Preliminary Consultation MONTGOMERY COUNTY HISTORIC PRESERVATION COMMISSION STAFF REPORT

Address: Smith Drive., Silver Spring Meeting Date: 11/12/2025

National Park Seminary Historic District

Proposal: Building Rehabilitation of the Castle and Villa Buildings and Construction of a New

Figure 4: East elevation of the Castle.

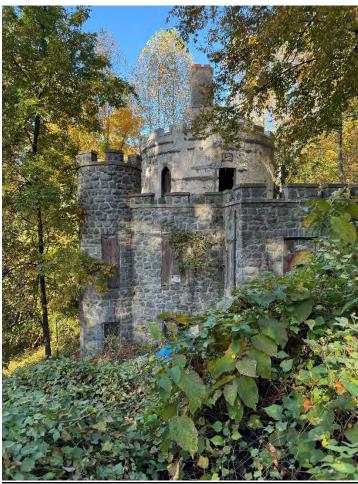
Staff supports the overall project objective of rehabilitating the historic Castle building and putting it to productive use. Unfortunately, due to the nature of the information presented in the application, Staff cannot provide more substantive comments on the proposed work.

In response to the submission, Staff has several questions related to the rehabilitation of the Castle.

- What plans has the Maryland Historical Trust reviewed?
- Are there any extant historic doors and windows installed behind the plywood?
 - o If so, what is their condition?
- What re-grading is proposed for the area immediately adjacent to the Castle?

Additionally, Staff has identified the following materials as necessary for the HPC to make a determination of appropriateness. These materials should be included in a submission for a second Preliminary Consultation.

- Existing and proposed Castle floorplans;
- Proposed elevation drawings;
- Detailed specifications for the treatment of the exterior walls;
- Material specifications for the doors windows;
- Any interventions necessary to satisfy contemporary building codes (i.e., ADA access, egress requirements, etc.).

Figure 5: Floorplan of the Villa, the section to the right was demolished shortly after recording the easement.

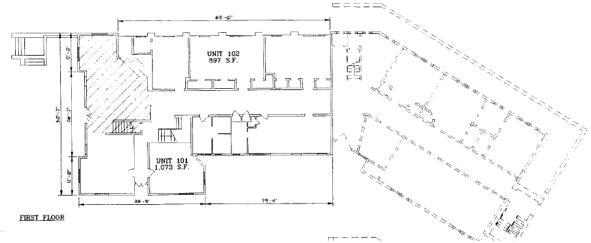
Based on a review of the 2001 HABS photographs and the 2004 easement documentation, Staff finds the Villa has substantially deteriorated over the last twenty years. Those documents show several wood windows and doors on the building as of 2004. No information about the condition of any of the historic materials was provided with the submitted materials.

Staff previously provided comments to the applicant that it did not find the proposed addition satisfied the *Secretary of the Interior's Standards for Rehabilitation*. This finding was largely based on the proposed size, massing, and the fenestration pattern of the proposed addition. The north elevation of the addition, including the new tower is 98' (ninety-eight feet) long, compared to only 77' 5 ½" (seventy-seven feet and five and one-half inches) for the original construction. The floorplans included in the easement documents show that the demolished rear portion was approximately 50% (fifty percent) of the total size of the building, however, the 30° angle helped to obscure its overall size (see *Figure 5*, above). The proposed addition will more than double the length of the north elevation. Additionally, the site plan shows that the centrally located tower will project beyond the north wall plane of the historic building. Staff finds additional revisions to the size, massing, and design are required to satisfy the *Standards*.

Figure 16: Section of the site plan showing the proposed reforestation area.

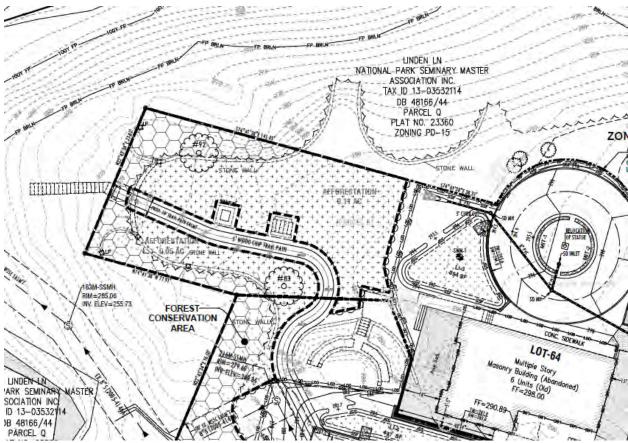
Staff does not find the proposed reforestation area is an appropriate treatment for what had historically served as a formal open space. Staff recommends this area be returned to a formal open space and the historic stone wall be restored. Additional discussions with Planning Department Staff on the appropriate location to satisfy the requirements of the Forest Conservation Plan should include HPC Staff to ensure the preservation of the cultural landscapes on site.

2 OF 4. VILLA ELEVATIONS: EXISTING & PROPOSED SECTIONS

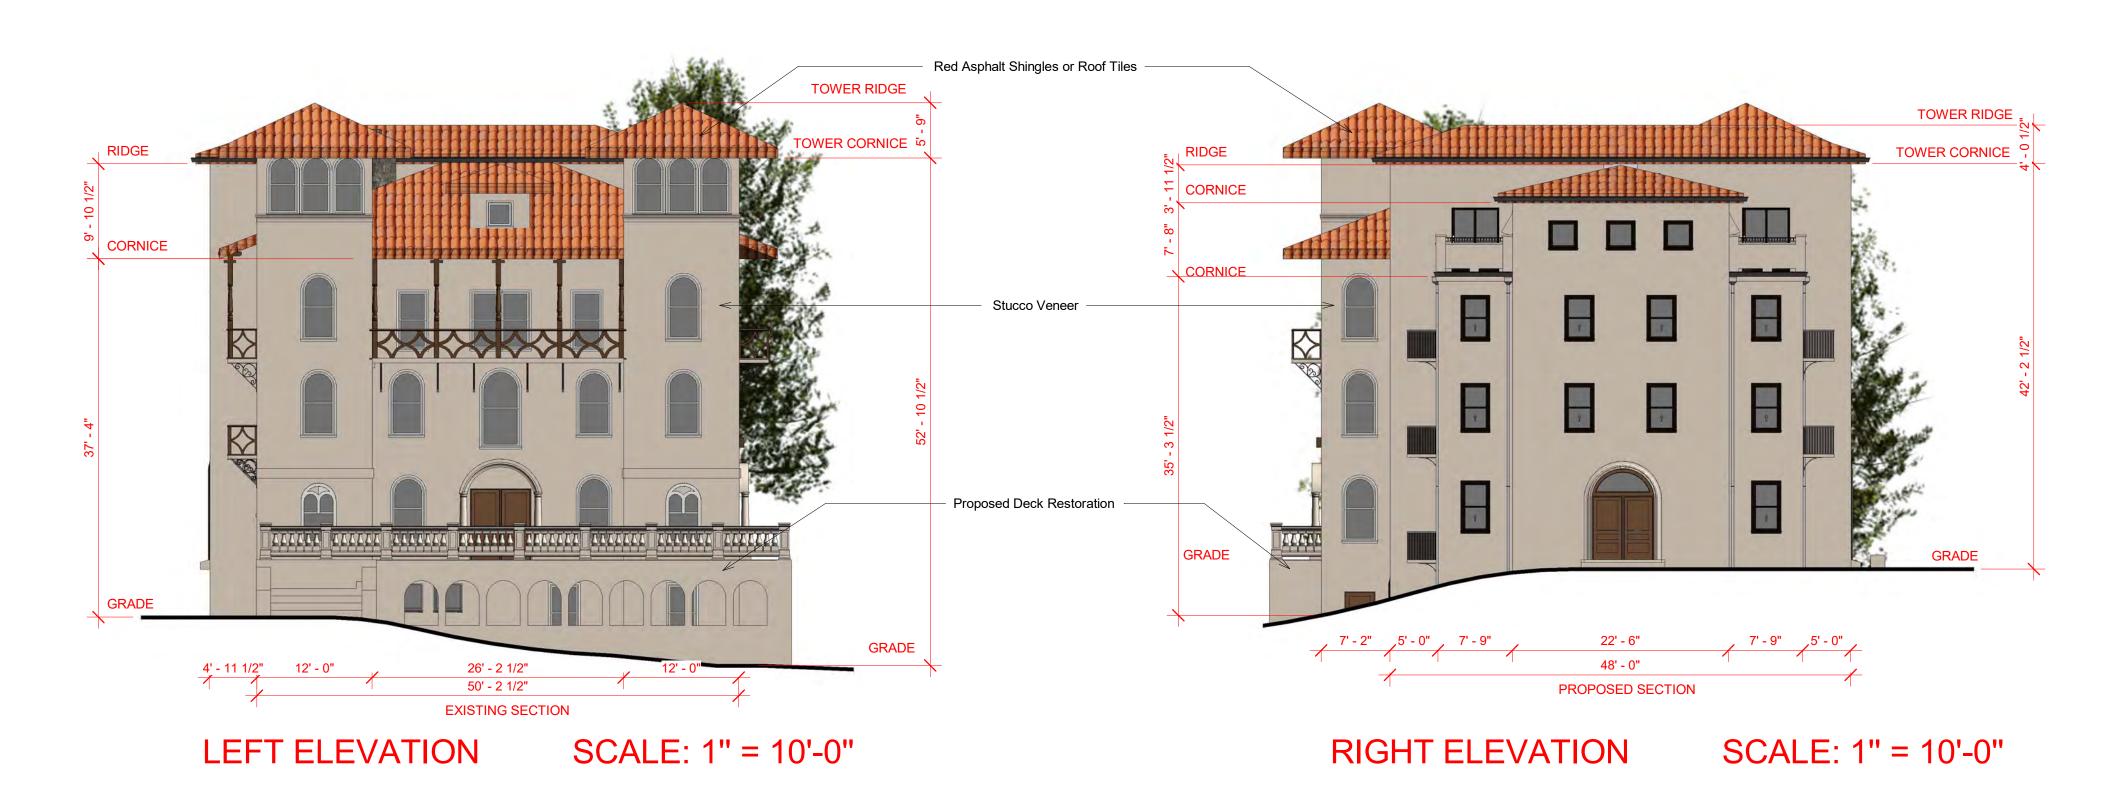
While Staff is generally reluctant to provide too much feedback on the design of the proposed addition at the risk of making recommendations that run counter to the MHT Easement committee, Staff finds that addition's design needs to be revised so that it has less visual impact on the historic construction. The applicant could use the form of the historic construction to help reduce the visual impact the addition will have on the Villa.

Staff's other preliminary comment is related to the proposed front deck. The submitted drawings identify this as a 'restoration.' Staff does not find the current deteriorated wood stairs to be the historic design, Staff is concerned that the scale and design of the proposed stairs risks creating a false sense of history, running afoul of *Standard #3*. Staff encourages the applicant to conduct additional research to identify a historic image of the Villa that will help to aid in the design of the front porch and/or confirm its overall size and design. An undated historic photograph (below) shows a portion of the front of the Villa, but is not clear enough to help identify materials and overall dimensions.

- What plans has the Maryland Historical Trust reviewed?
 - o What is the feedback to date?
- Are there any extant historic doors and windows installed behind the plywood?
 - o If so, what is their condition?
- The plans identify a proposed deck restoration. Has the applicant located any historic photos beyond what has been presented in this Staff Report that show this deck, or are its design and dimensions conjecture?

- Detailed documentation of the existing building condition;
- Existing and proposed Villa floorplans;
- Proposed notated elevation drawings;
- Detailed specifications for the treatment of the exterior features;
- Material specifications for the doors windows;
- Any interventions necessary to satisfy contemporary building codes (i.e., ADA access, egress requirements, etc.).

3 OF 4. PROPOSED TOWNHOME SOUTH ROW ELEVATIONS

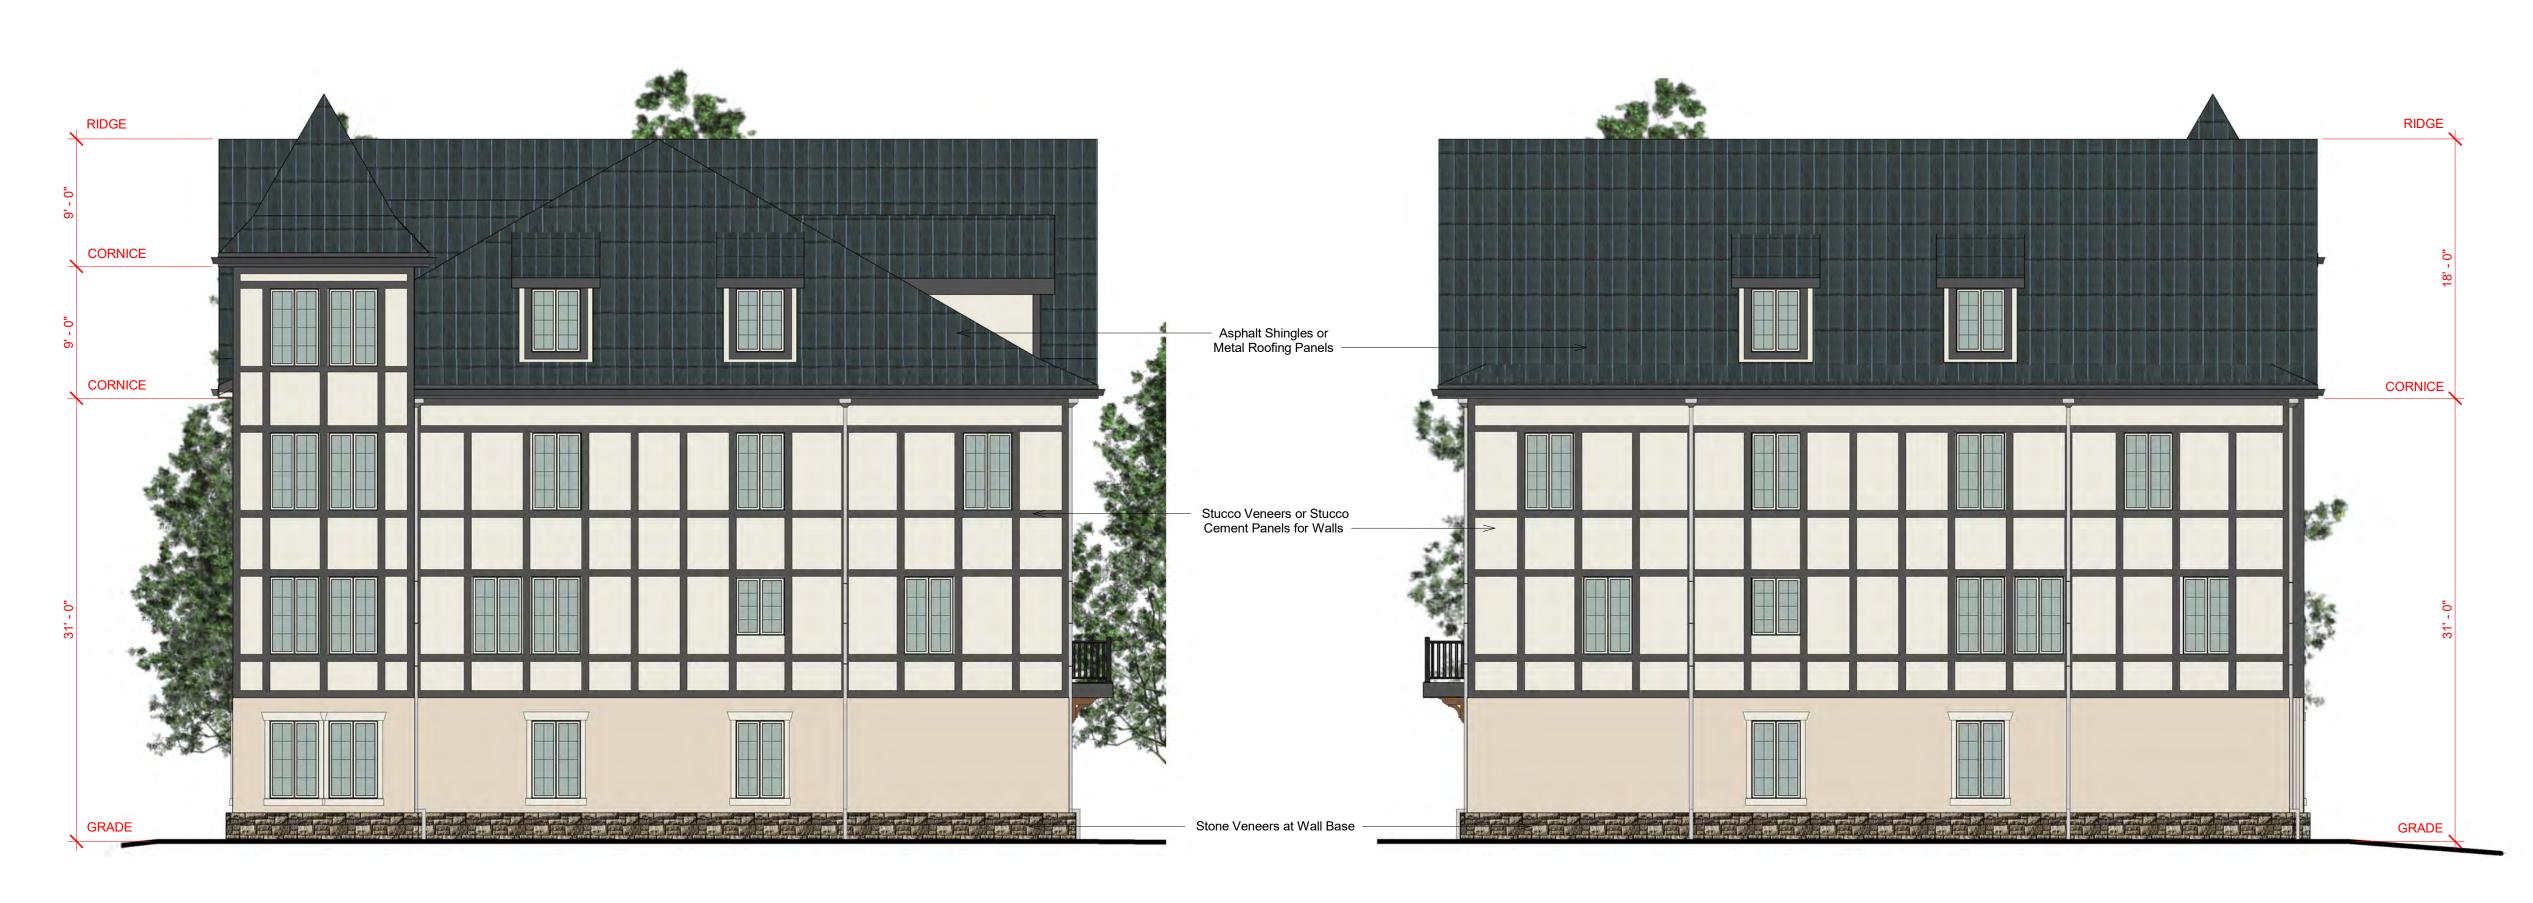
Based on the notes on the drawings, both buildings will be 49' (forty-nine feet) tall from grade and approximately 84' (eighty-four feet) wide. The townhouse buildings will be oriented so the 'rear' garages are accessible from a central driveway. Both buildings will have a stone veneer ground floor with stucco above. No other material specifications were included in the submitted materials.

Staff finds the proposed location to be appropriate. The townhouses are set apart from the historic buildings and will not impact the relationship between the Villa and the Castle. Staff finds the form of the two four-unit buildings is sufficiently contemporary and that they will not be misidentified as historic construction (per *Standard #9*).

Staff finds the footprint of the proposed townhouse buildingss are generally consistent with what was construced in the western portion of the site. The height of the proposed townhouses appear to be slighly taller than the previously constructed townhouses; perhaps by as much as 5' (five feet) however, Staff does not find these two buildings will overwhelm either the Castle or the Villa, as the new buildings will be separated from the historic both in distance and grade so they stand apart.

Staff finds that stucco siding is generally appropriate for new construction in this area of the historic

district, as it is used on both the Villa and portions of the Castle. Recent experience with stucco cement panels leads Staff to recommends against them as the expansion joints create an appearance that is not consistent with traditional architecture. Information on the other materials, except for the asphalt shingles, was not provided and should be included with the next submission. Staff finds that in the National Park Seminary most of the materials should be those employed in traditional architecture (i.e., wood doors, wood or metal clad windows, cement stucco siding, etc.).

- Annotated elevation drawings and
- Detailed material specifications.
